**MASTER PLAN MODIFICATION AND  
RELOCATION OF METRO ENTRANCE FACILITY  
THE PENTAGON  
Arlington County, Virginia**

Report to the Department of Defense

October 5, 2000

MEF BUILDING ELEVATIONS

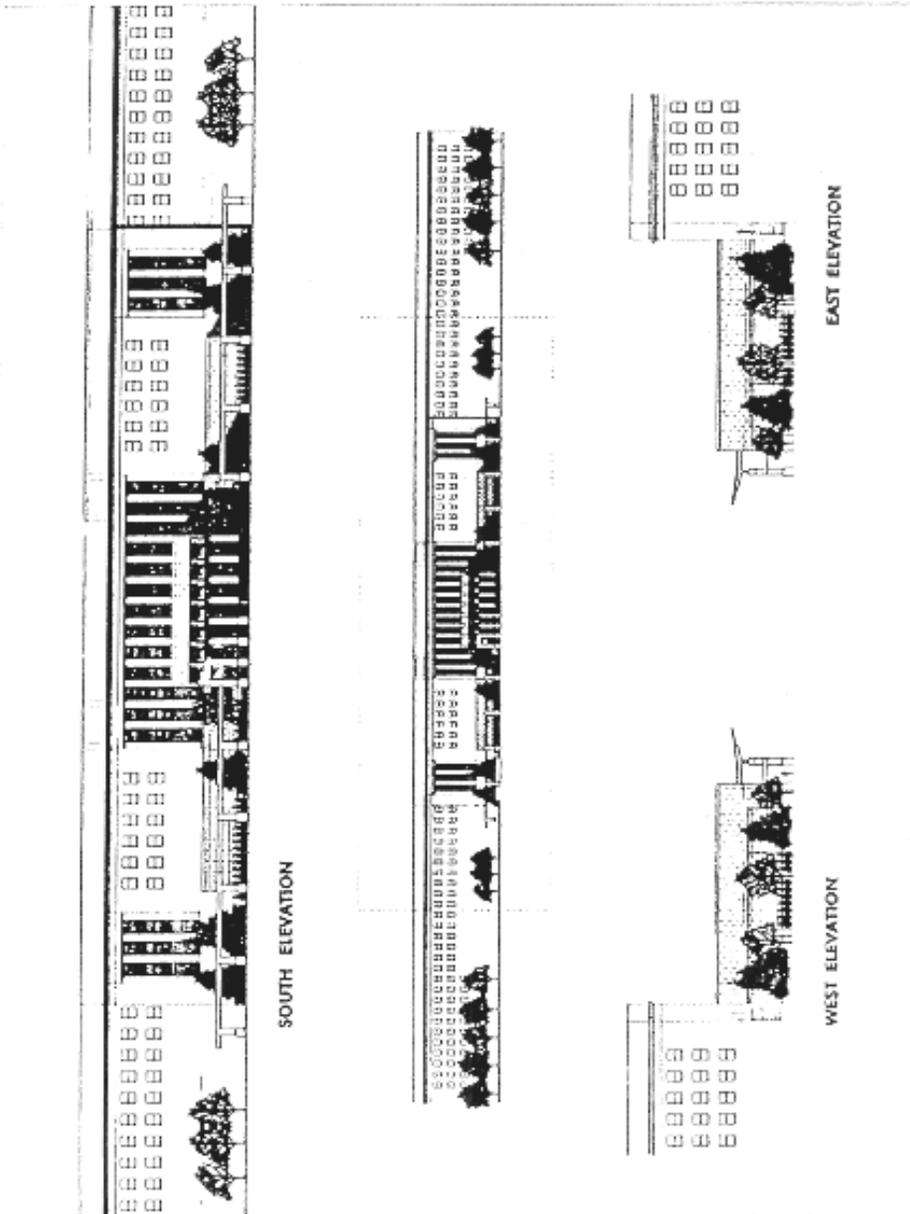
- The MEF building façade with the objective of presenting a more inviting and transparent entrance to the facility.

LANDSCAPE PLAN

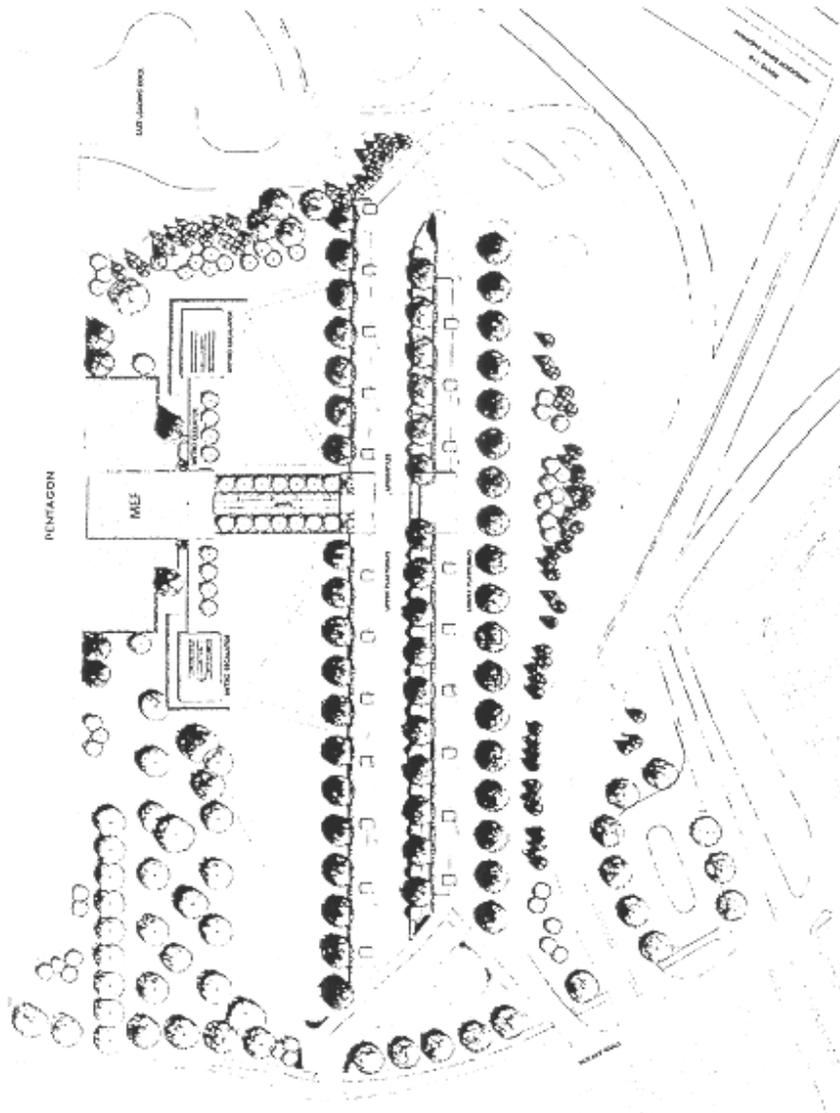
- The canopy system with the objective of providing more inclement weather protection for pedestrians and better defining the facility's identity in relation to the Pentagon Building while meeting necessary security requirements.
- The pedestrian plaza and walkways directly adjacent to the MEF building with the objective of enlarging the plaza to ease pedestrian circulation.
- The grassy areas between the bus terminal and MEF building with the objective of better defining purpose of open space, softening walkway alignments, and providing more visual interest in the area. These areas could be designated for public art or memorial use.
